California Regional Water Quality Control Board Central Valley Region

PHASE II HYDROGEOLOGIC CHARACTERIZATION REPORT – VALLEY WASTE DISPOSAL COMPANY – CYMRIC FIELD STUDY AREA, KERN COUNTY

The enclosed memorandum prepared by Central Valley Regional Water Quality Control Board (Central Valley Water Board) staff contains a review of the 24 April 2007 Phase II Hydrogeologic Characterization Report for the Valley Waste Disposal Company (VWDC) McKittrick 1 Facility prepared by Geomega Inc.

TO: Shelton R. Gray
Senior Engineering Geologist

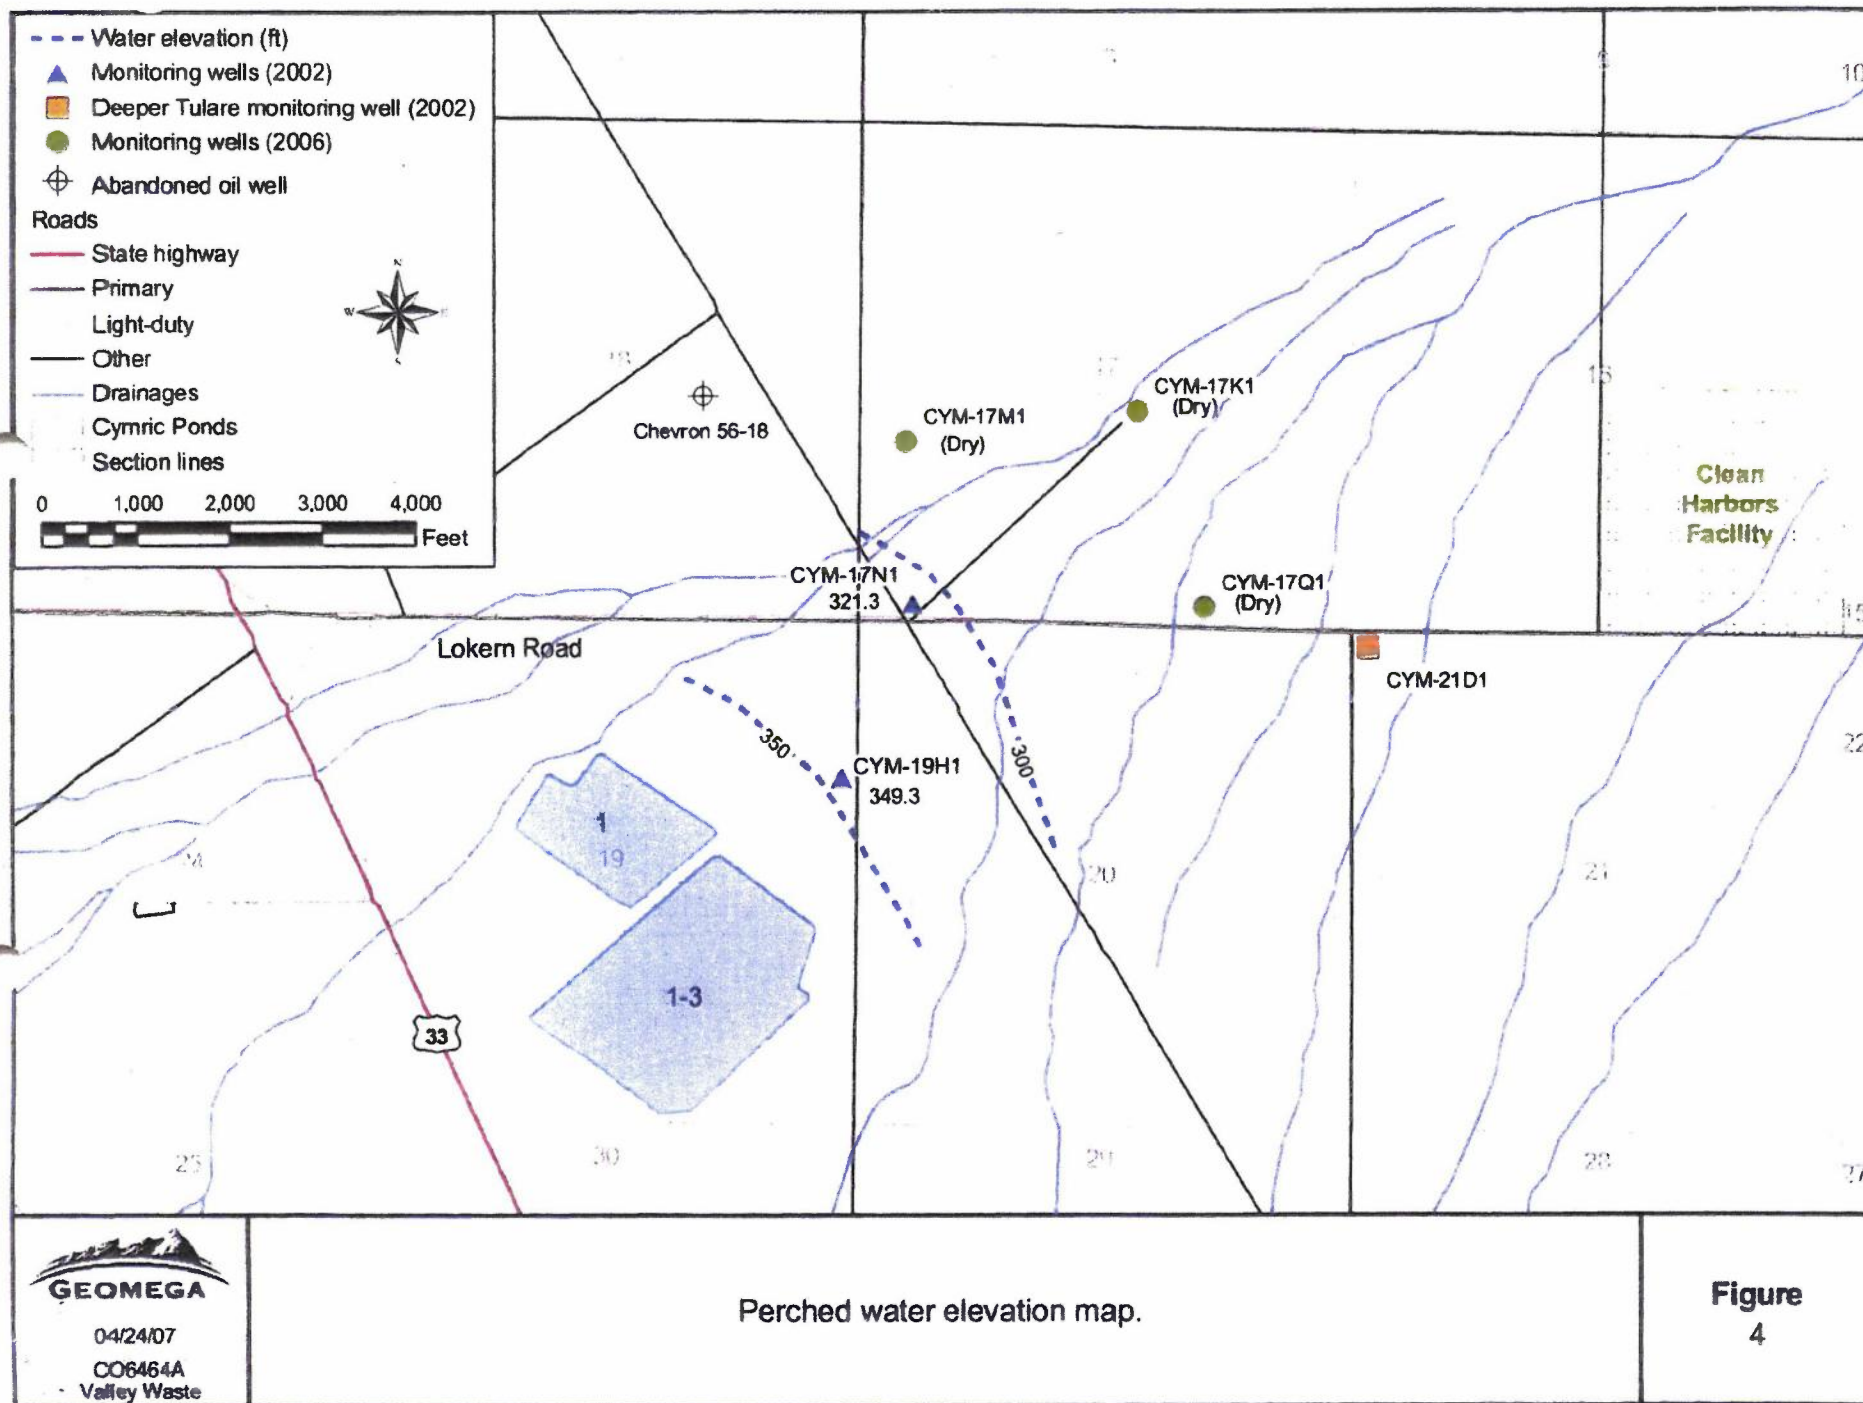
The impact at well CYM-17N1 consists of 25 feet of wastewater perched on top of an Upper Tulare clay from 165 to 200 ft., and has apparently not migrated as far as well CYM-17K1 (refer to attached Modified Figure 3). At well CYM-17K1, the Upper Tulare perching clay occurs from approximately 188 to 225 ft.

Three vadose zone wells (CYM-17K1, CYM-17Q1, and CYM-17M1) installed during 2006 as part of the Phase II hydrogeologic characterization indicated that the leading edge of wastewater migration occurs in the southwest corner of Section 17, T29S, R22E, MDB&M near Phase I well CYM-17N1. The wastewater is perched on an upper Tulare Clay layer and has saturated upper Tulare sands lying above the clay layer in Phase I characterization wells CYM-19H1 and CYM-17N1, up-gradient of the Phase II vadose zone wells (see Modified Figure 3 & Figure 4).

Figure
4

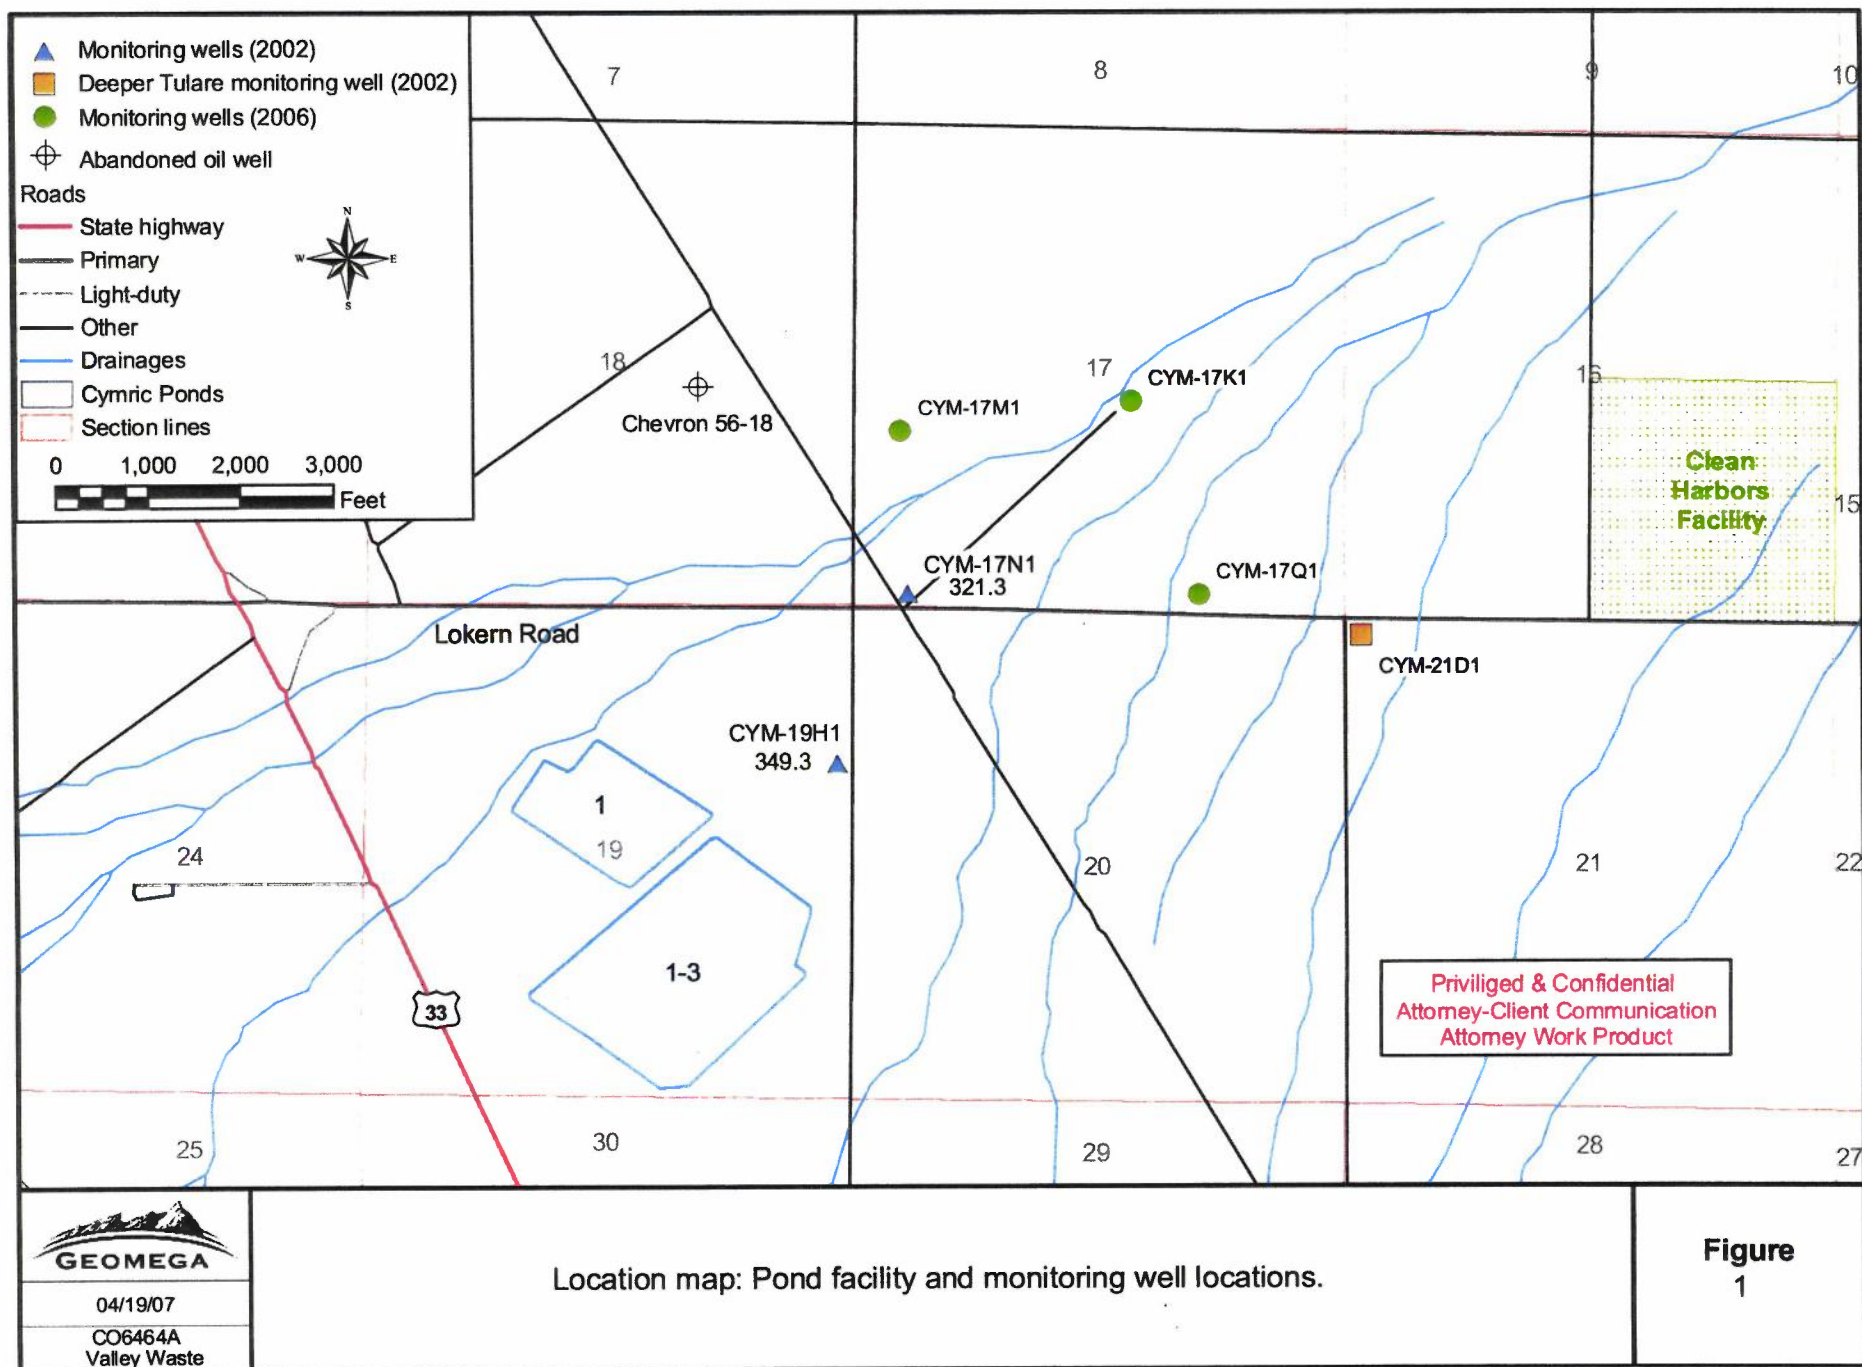
A Phase I Hydrogeologic Characterization conducted during November 2002, involved drilling and installing three monitoring wells (CYM-19H1, CYM-17N1, and CYM-21D1) northeast of the Facility (see attached Figure 4 from Phase II Characterization Report). The Facility is in Section 19, T29S, R22E, MDB&M off the east flank of the Cymric Oil Field. The purpose was to determine the extent of subsurface wastewater migration from the ponds.

The Phase II Hydrogeologic Characterization Report (Report), dated 24 April 2007, was prepared by Geomega Inc., for VWDC. The characterization field work was conducted during August and September 2006 and involved the drilling and installation of three wells (CYM-17K1, CYM-17Q1, and CYM-17M1) to delineate the lateral extent of wastewater migration beyond Well CYM-17N1. The location of the wells is shown on attached Figure 4 from the Phase II report.
